THE
NATIONAL
BOARD
OF BOILER AND
PRESSURE VESSEL
INSPECTORS

SUBCOMMITTEE ON INSTALLATION

AGENDA

*Meeting of January 16, 2013
Mobile, Alabama*

Figure 1

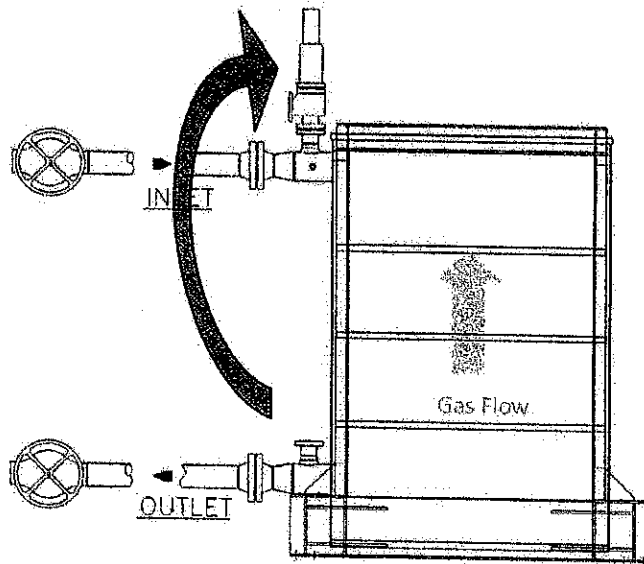
An example would be a vertical counterflow economizer where the inlet header is located above the outlet (as in Figure 1) If the designer can specify where the PSV be located then the PSV may be placed such that the release of energy, via steam, happens more slowly through the same size PSV.

Figure 1 illustrates a counter-flow economizer, in a vertical up gas path, having horizontal headers, with the outlet header below the inlet. When this type of economizer is isolated during operation, and the PSV is tripped, steam will begin to collect in the upper "inlet" header. This design allows a more controlled venting of isolatable economizers by venting steam instead of hot water. Figure 1 also illustrates moving the safety relief valve from the outlet to the preferred location.
